Administrative Design Review

PROJECT #3033307-LU:
DELRIDGE WAY TOWNHOUSES
8417 DELRIDGE WAY SW
Seattle, WA 98106

Comment Summary_Markup Summary

EXISTING BUILDINGS IN IMMEDIATE CONTEXT

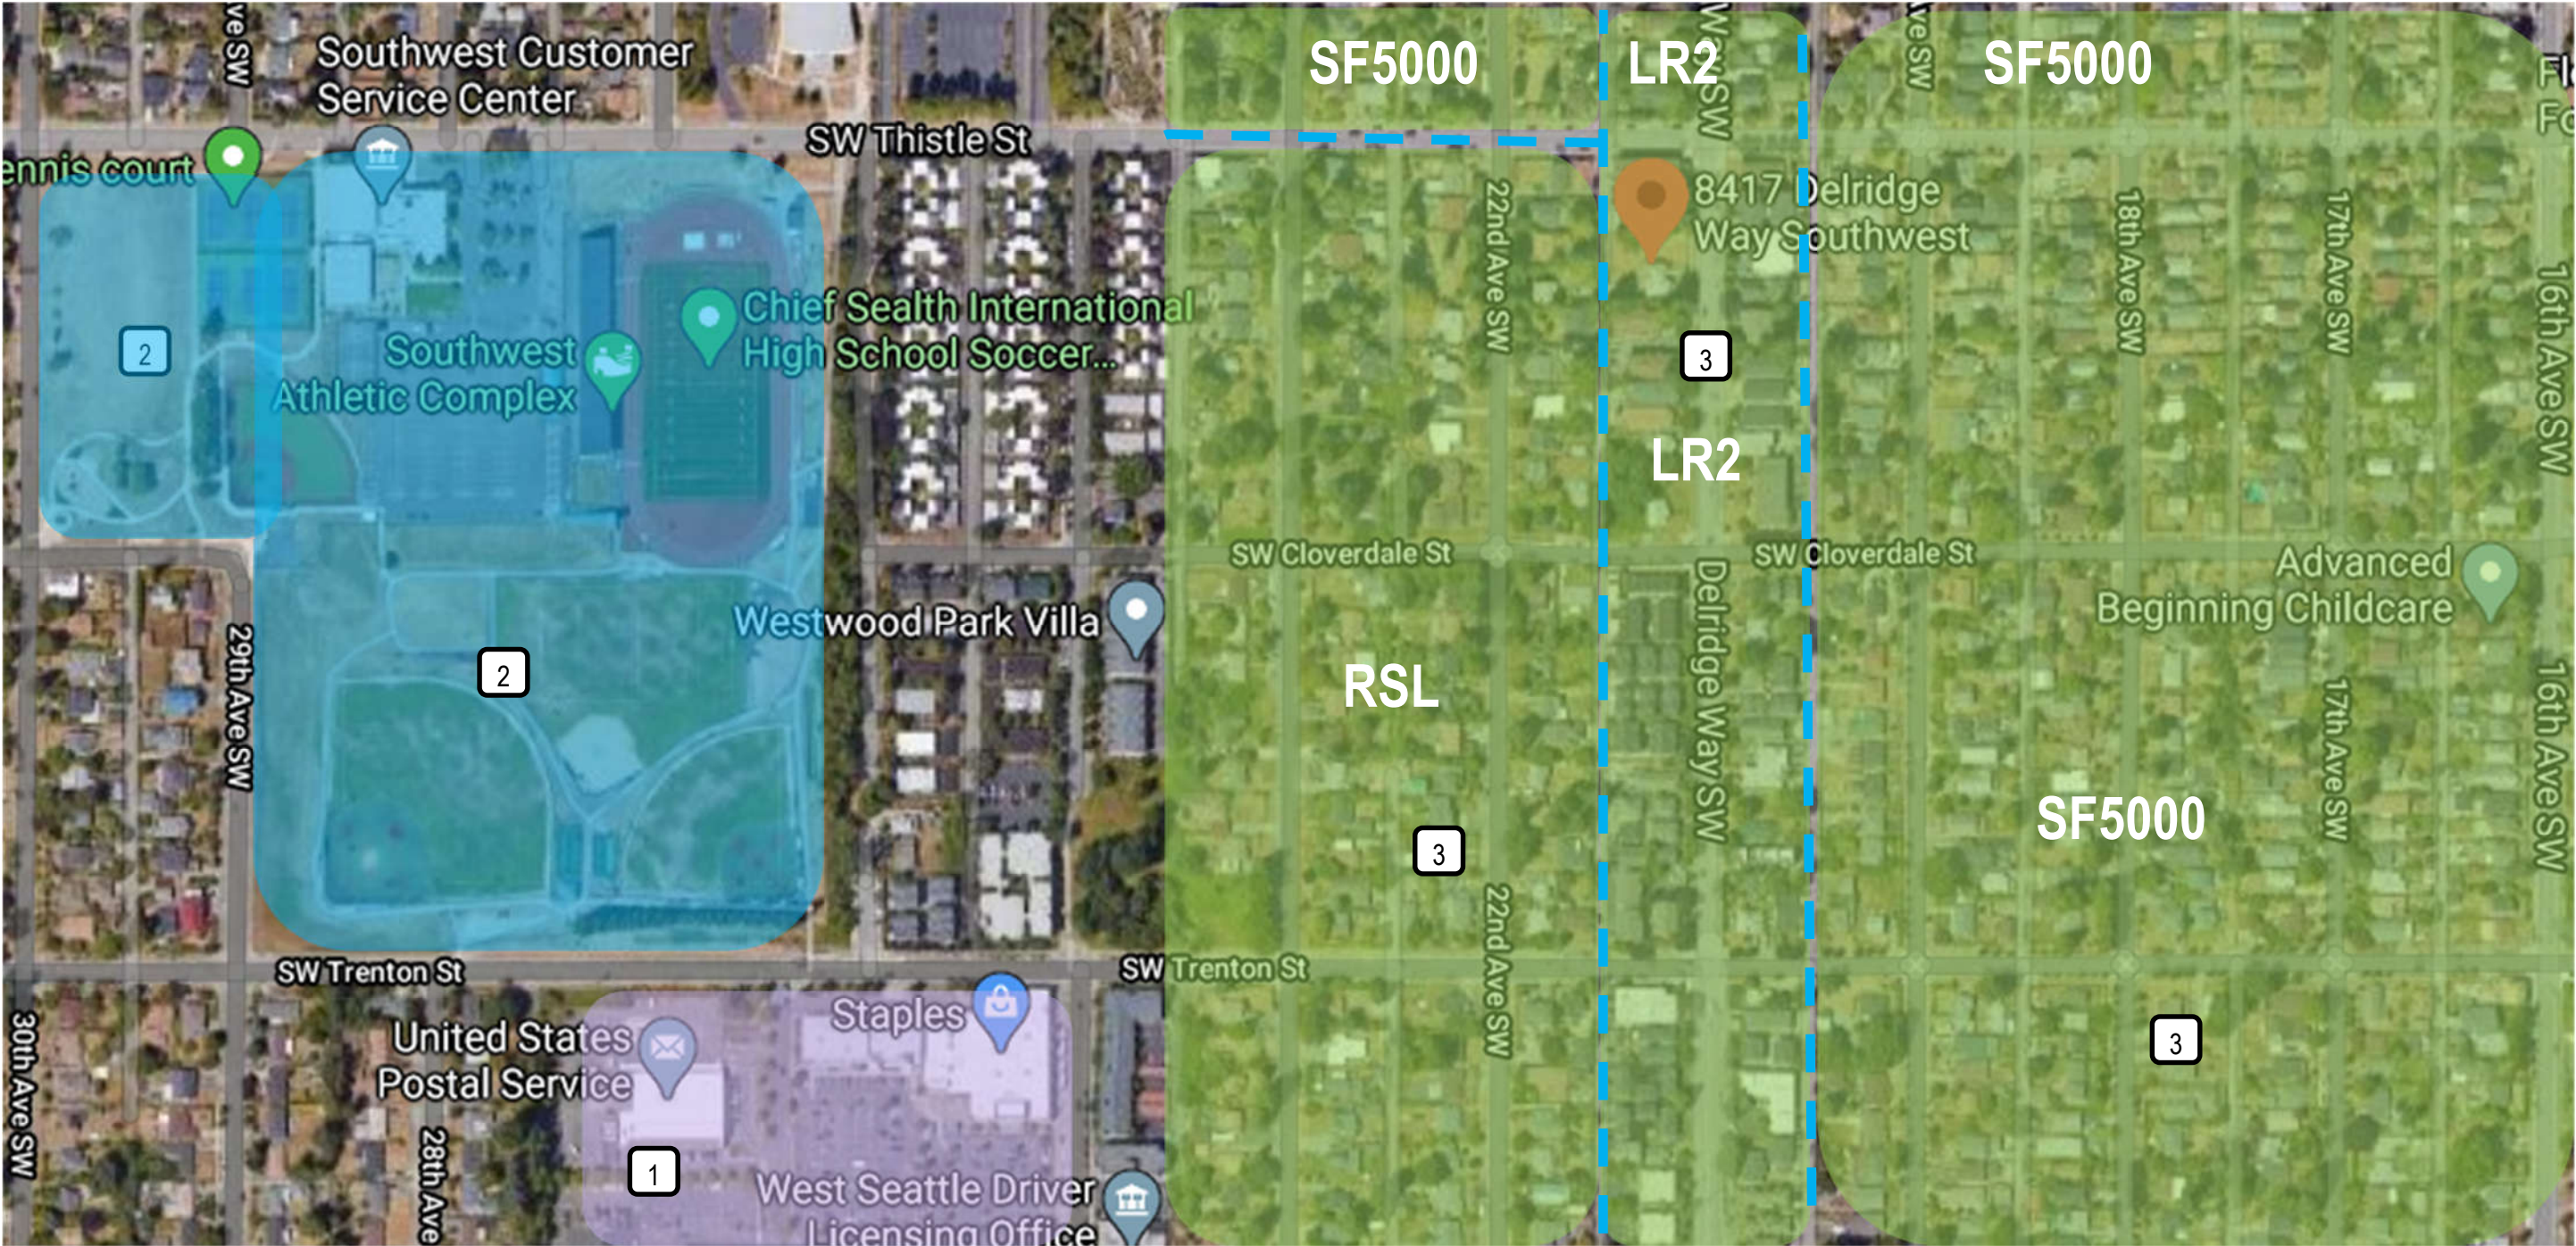
Context analysis does not support a long row of townhomes aligned with the street with no major modulation. Provide images of comparable developments in the immediate vicinity.

SITE SURVEY

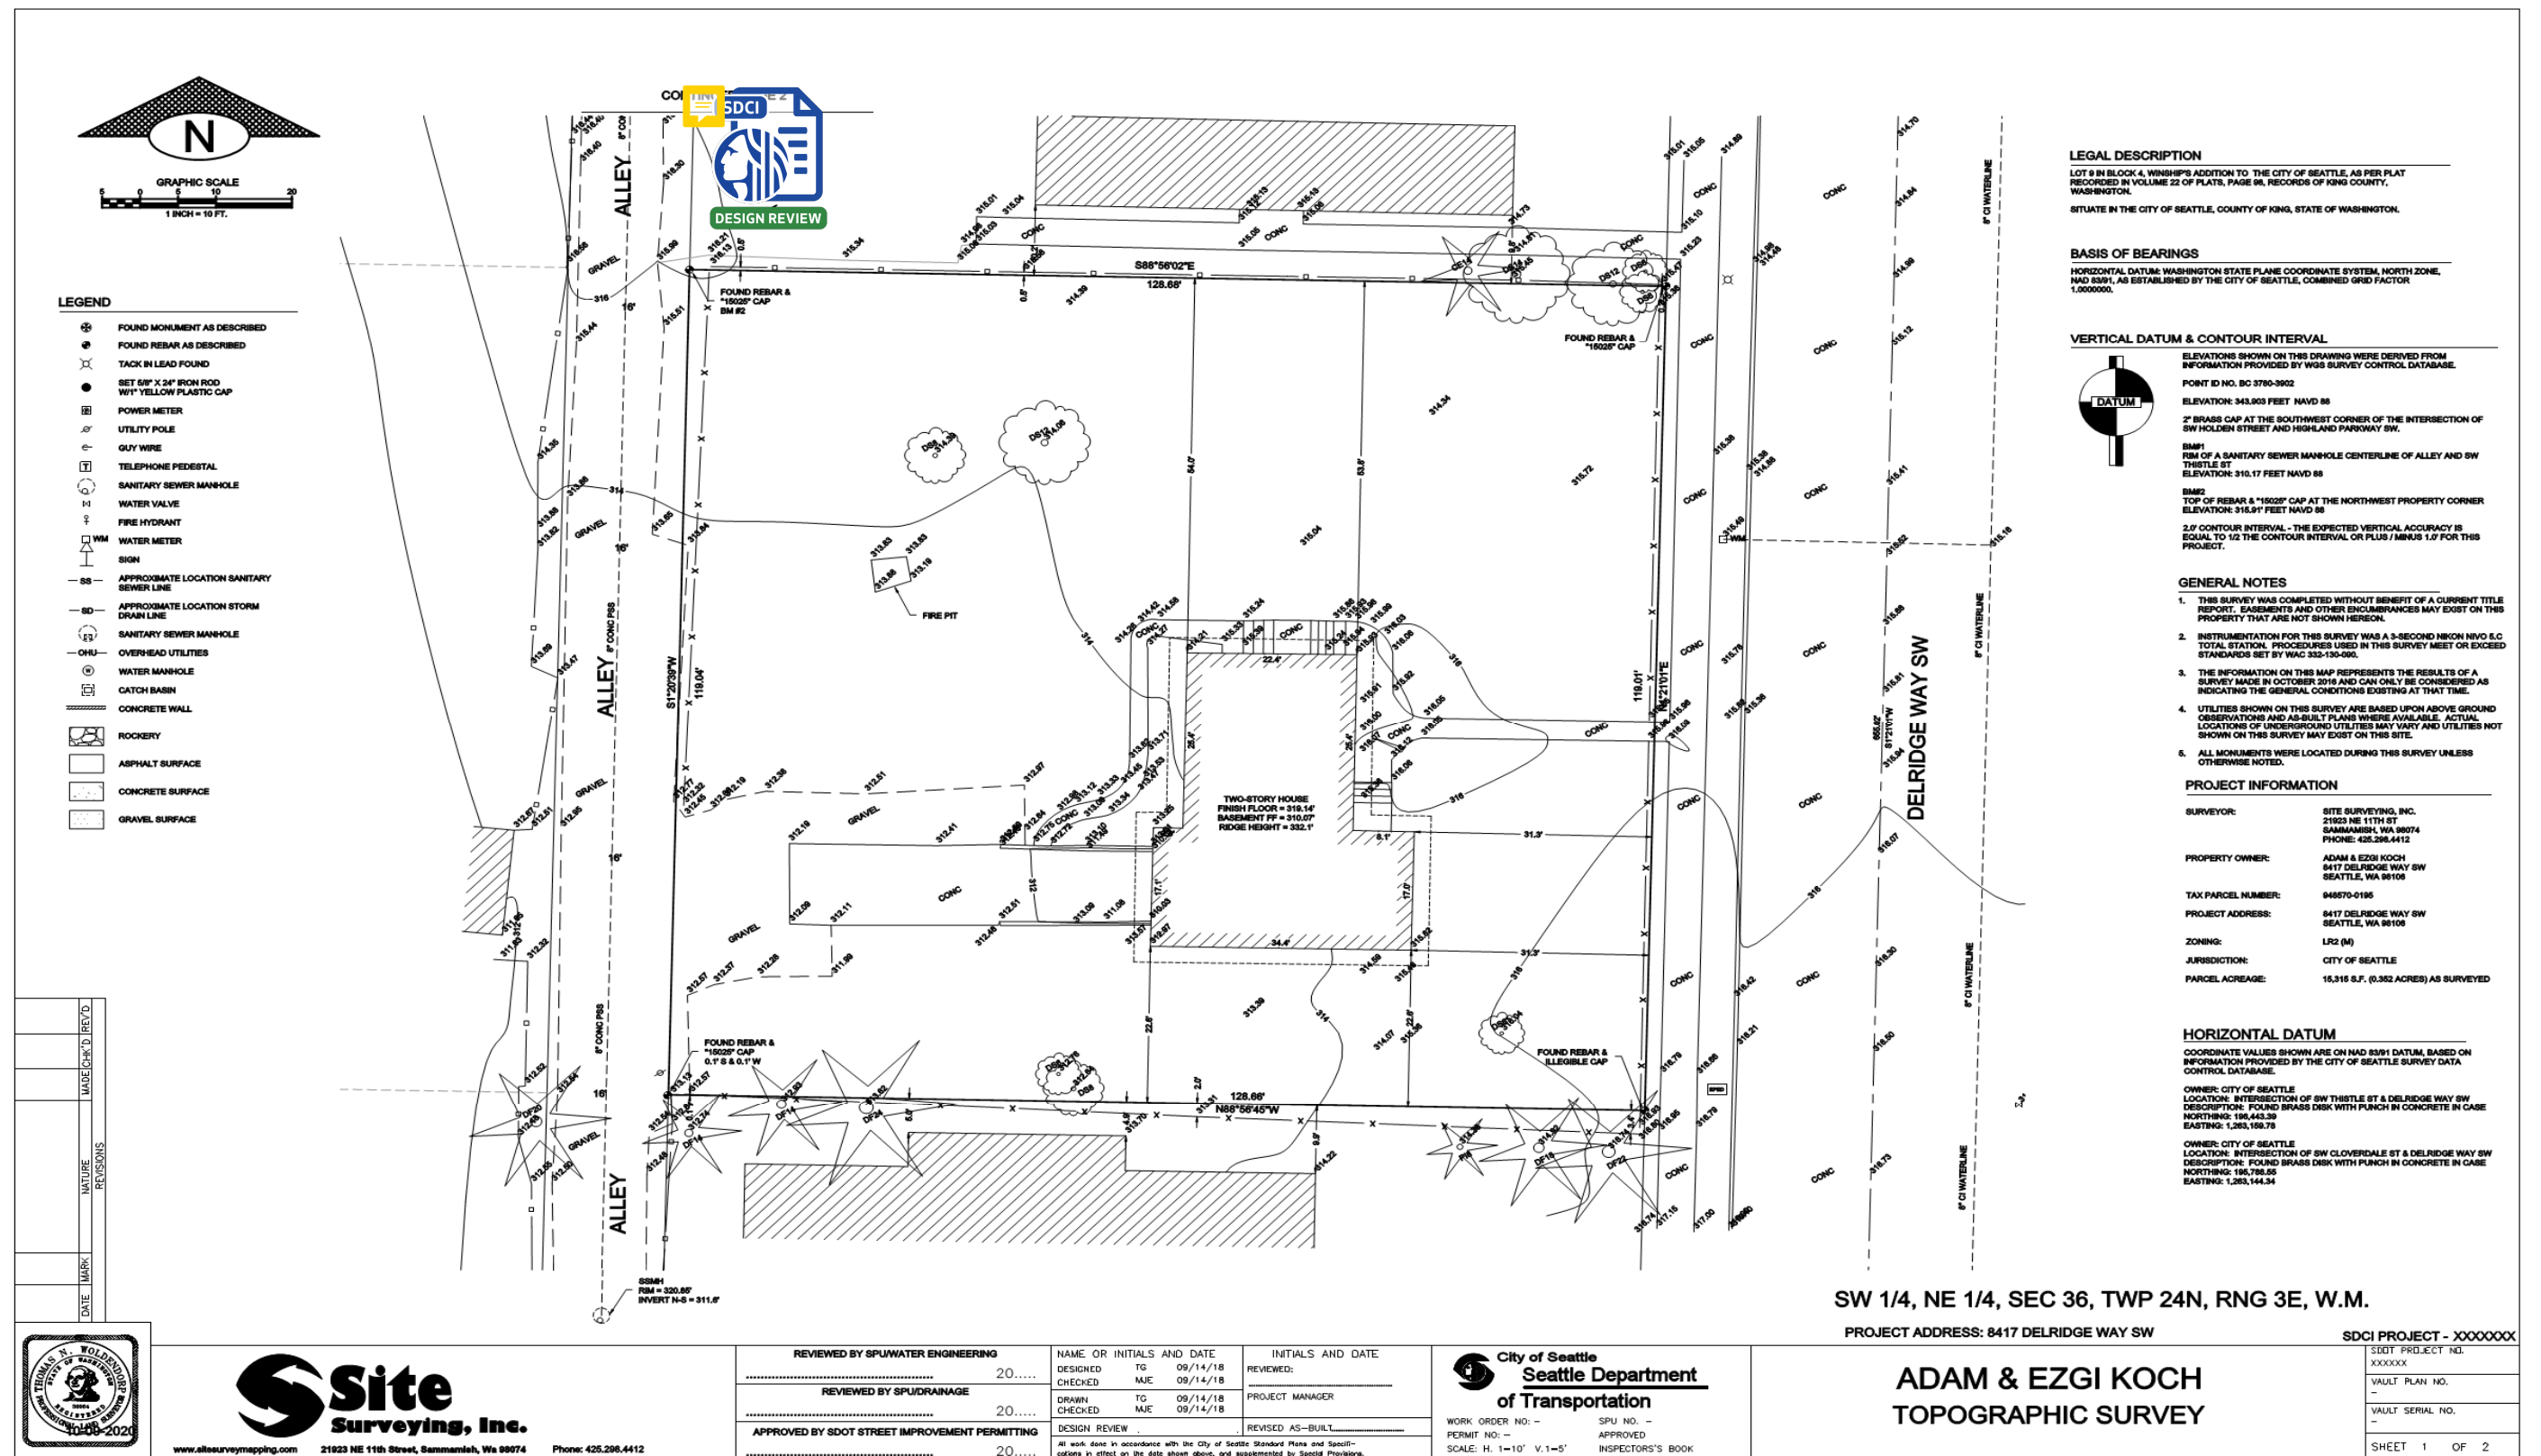
Provide spot elevations at the corners of the site so that the amount of grade along the street frontage and alley is easily determines and across the site east-west.

Also include information on the existing trees, their size and if they are Exceptional. This can be provided in a simple memo from an arborist.
